APPEAL SUMMARY

Appeal ID: 24868	Project Address: 7240 NE Airport Way
Hearing Date: 5/12/21	Appellant Name: Scott Thayer
Case No.: B-008	Appellant Phone: 5037245294
Appeal Type: Building	Plans Examiner/Inspector: Elgin Rowland
Project Type: commercial	Stories: 4 Occupancy: A-3, B Construction Type: II-B
Building/Business Name: PDX RCC Office Building	Fire Sprinklers: Yes - Throughout
Appeal Involves: Erection of a new structure	LUR or Permit Application No.: 18-162608-CO
Plan Submitted Option: pdf [File 1]	Proposed use: Office, Retail Rental Car Center

PARKING AND CONSOLIDATED RENTAL FACILITY
RCC - FLOOR 1 - SECTOR 1A - FLOOR PLAN

RCC FLOOR 1 20x20 JUNCTION BOX LOCATION

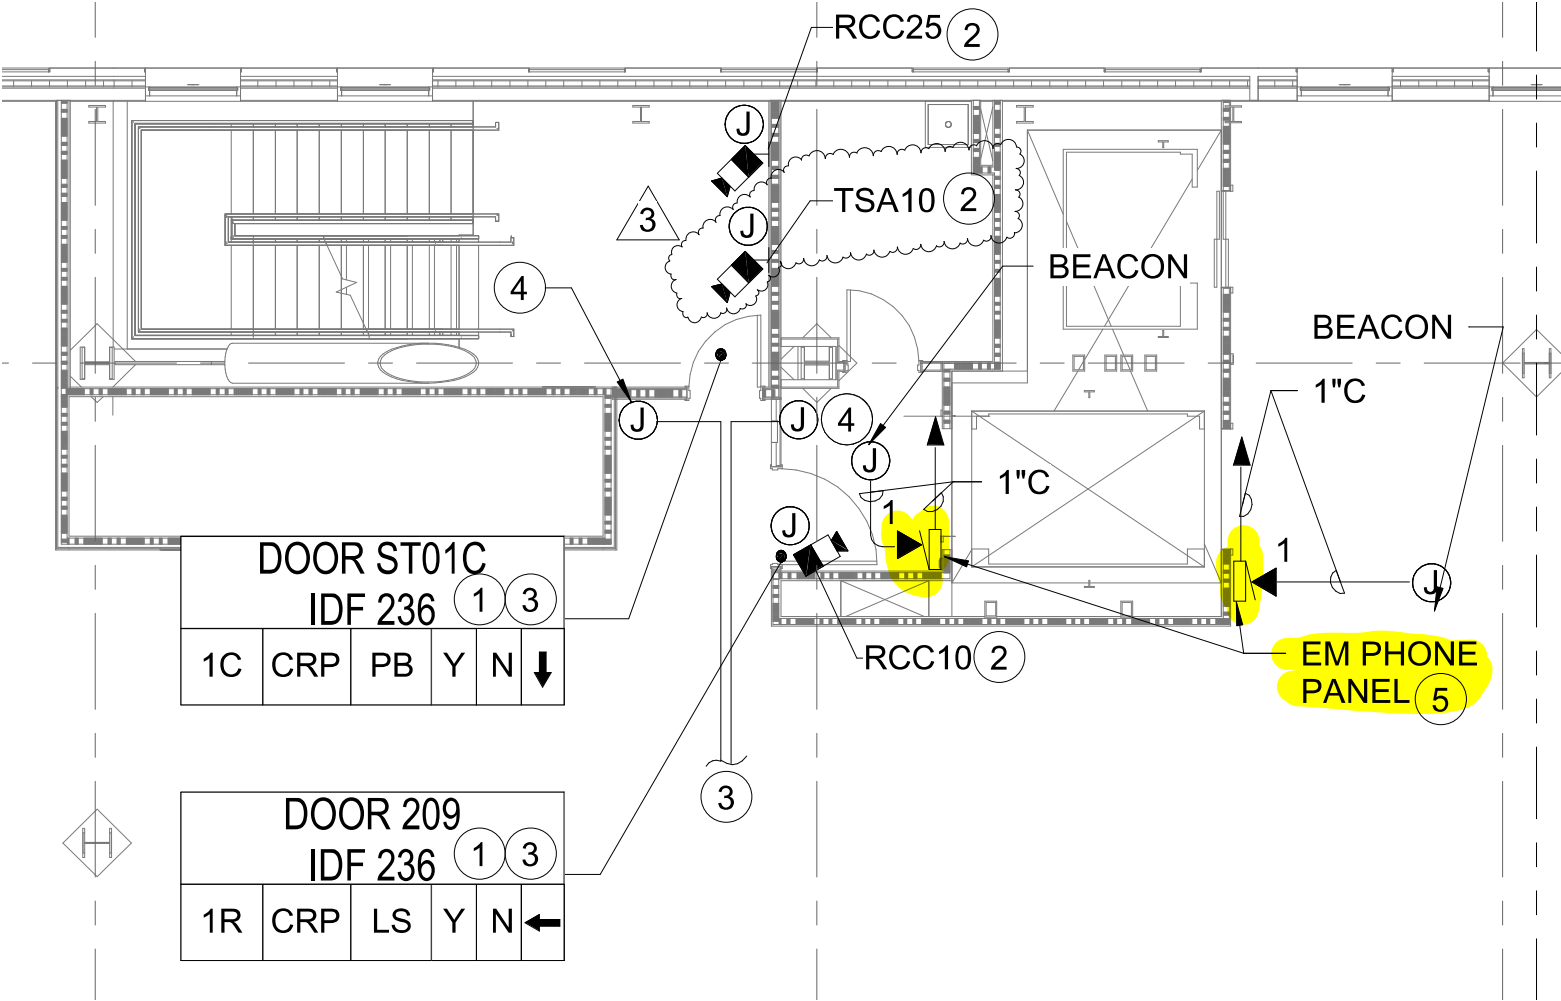
Code Section	2014 OSSC 713.8.1
Requires	713.8.1: Penetrations other than those necessary for the purpose of the shaft shall not be permitted in shaft enclosures.
Code Modification or Alternate Requested	Allow penetration of gypsum membrane on outside of Elevator Shaft Wall assemblies for specific junction boxes, based on 2019 OSSC code provisions and Engineering Judgements.
Proposed Design	<p>Provide recessed junction boxes penetrating outside gypsum membrane of elevator shaft wall assemblies, with fire sealant, in specific locations as follows:</p> <p>RCC Elevator Shaft RCC-EL01/02, Floor 1: 20"x20" Junction Box RCC Elevator Shaft RCC-EL01/02, Floors 1-5: 8"x11" Emergency Phone J-Boxes See attached plans for proposed locations, and attached Engineering Judgements for the specific junction box membrane penetrations proposed.</p> <p>2019 OSSC provides a relevant Exception to 713.8.1 as follows: 713.8.1, Exception: Membrane penetrations shall be permitted on the outside of shaft enclosures. Such penetrations shall be protected in accordance with Section 714.4.2. 714.4.2: Membrane Penetrations. Membrane penetrations shall comply with Section 714.4.1 (through penetrations). Where walls or partitions are required to have a fire-resistance rating, recessed fixtures shall be installed such that the required fire resistance will not be reduced.</p> <p>The attached Engineering Judgements confirm that the proposed junction boxes penetrating the outside membrane will not reduce the required 2-Hour fire-resistance rating of the RCC Elevator Shaft Enclosure.</p>

Reason for alternative	Recessing of the Emergency Phone boxes is required to avoid non-compliance with Accessibility Code limitations on projections from the face of wall, and recessing the 20"x20" junction box is

required to provide adequate access to the box which is otherwise limited by adjacent construction.

Junction box penetration of elevator shaft wall that is not necessary for the purpose of the shaft: Granted provided the junction boxes are installed in compliance with 2019 OSSC Section 714.4.2.

F Rating - 2 HR

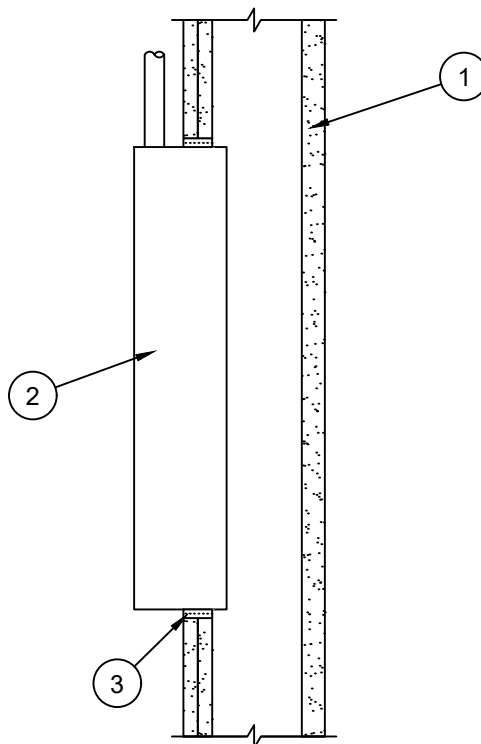
1. **Wall Assembly (2 Hr)** - Gypsum board/steel stud shaft wall assembly (UL U, V or W400 Series Design).
2. **Junction Box** - Max 20" x 20" (or smaller) steel junction box min 16 GA with steel cover. Annular space is min 1/4" to max 1/2".
3. **Sealant** - SpecSeal® LCI Sealant applied within annular space to full depth, flush with outer wall surface.

Notes: 1 - T rating may not equal F rating per UL263.

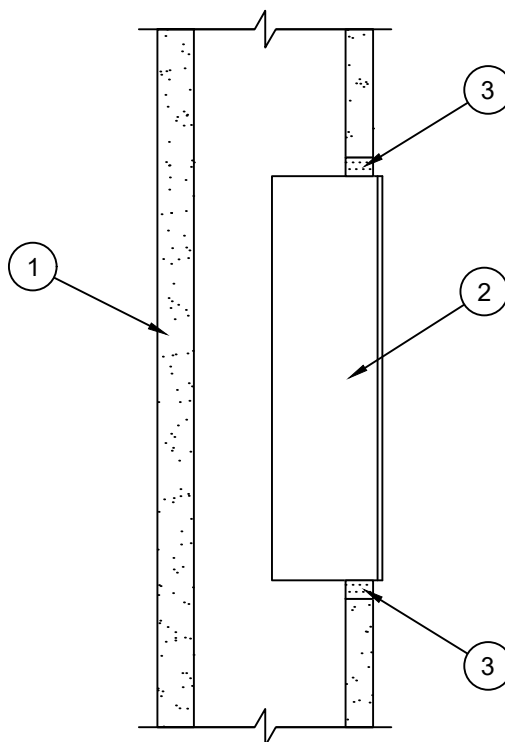
- 1. Wall Assembly (2 Hr)** - Gypsum board/steel stud shaft wall assembly (UL U400 Series Design). Wall consists of steel stud framing, min 1" thick gypsum liner panel and min 3/4" thick Type X gypsum board on the finished side of wall.
- 2. Electrical/Junction Box** - Max 8" x 11" (or smaller) min 16 GA (or heavier) steel electrical box with steel face plate. Box penetrates finished side of wall only. Annular space is min 1/4" to max 1/2".
- 3. Sealant** - SpecSeal® LCI Sealant applied into annulus to full depth of gypsum board, flush with wall surface.

***Notes:** **1** - Rating of the firestop system is dependent on the performance of the electrical box under fire exposure with a maximum possible F rating of 2 Hr. **2** - T rating may not equal F rating per UL263.
